Consultant Advice Note

Job Number: 14794
Project Title: Manchester Art Gallery, Consultant Advice Note
Doc Ref: 14794-BKP-14-ZZ-TN-S-0003
Purpose of Note: Highlight structural failures that require remediation

Date: 13 May 2024

1 George St - Lintel 1

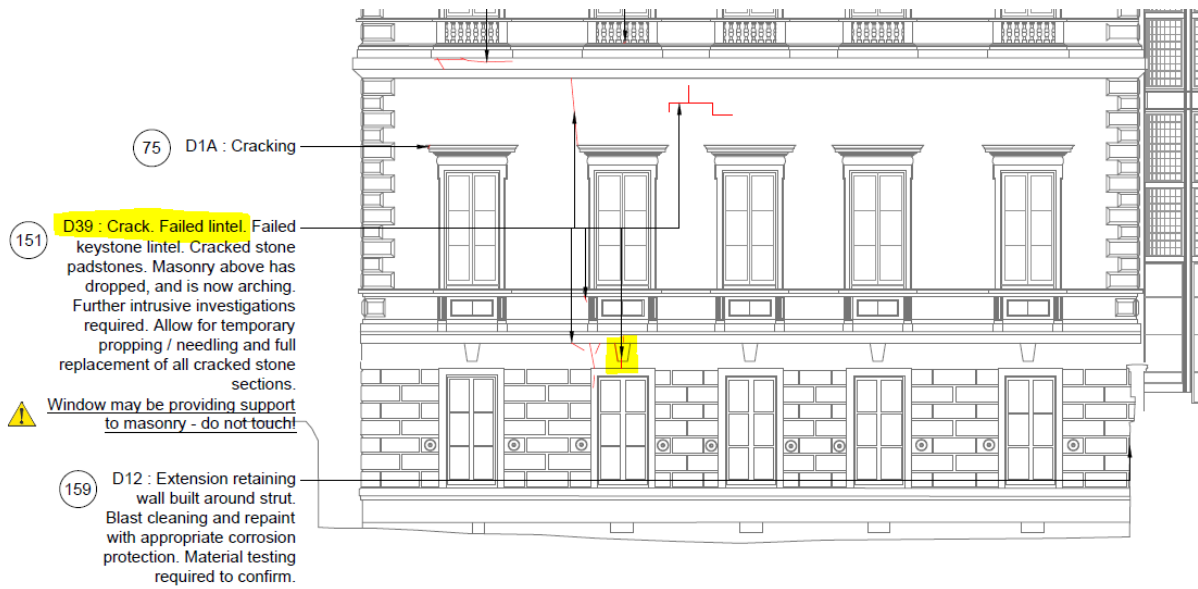
The lintel has a wide crack (5mm) through the centre, and a shear crack to the left-hand bearing. The lintel has dropped, and is likely now supported by the window frame. It appears to be historical, however, it has resulted in the keystone above slipping, and the likely cause for the masonry above to have settled.

Due to the position of the windows above, the whole panel has dropped, and the masonry panel above the first floor windows is now arching, resulting in the crack pattern observed in the bed and perpend joints.

The lintel presents a risk to any works around the window, as this is highly likely to be supporting the lintel.

The lintels need to be replaced, which will require Temporary propping, both internally and externally. The keystone lintels will require to be taken down and reset in the correct position. A detailed method statement for reinstatement will need to be developed in tandem with a conservation masonry specialist.

In the meantime, we strongly recommend that temporary props are installed to the window heads to prevent any further movement and relieve any load on the window frames.

2 Princess St, Lintel 2

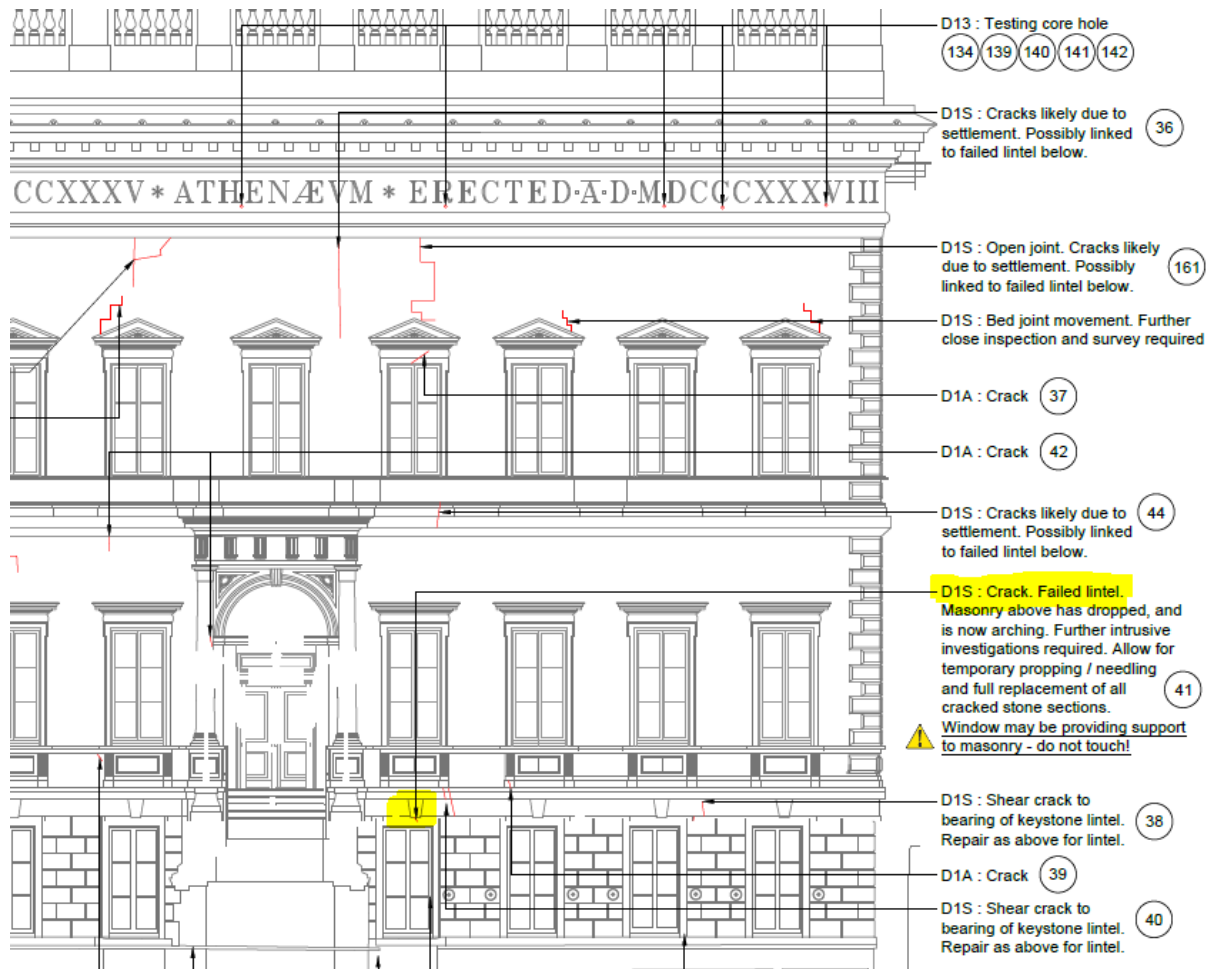
The lintel has a crack (3mm) diagonally across the centre, with a flexural crack to the right-hand bearing. The lintel has visibly dropped due to the diagonal nature of the crack, and is likely now supported by the window frame. It appears to be historical, however, it has resulted in the keystone above slipping, and the likely cause for the masonry above to have settled.

Due to the position of the access door and windows above, it is not clear if the masonry panel has dropped, or if there is another cause of the crack pattern observed in the bed and perpend joints above.

The lintel presents a risk to any works around the window, as this is highly likely to be supporting the lintel.
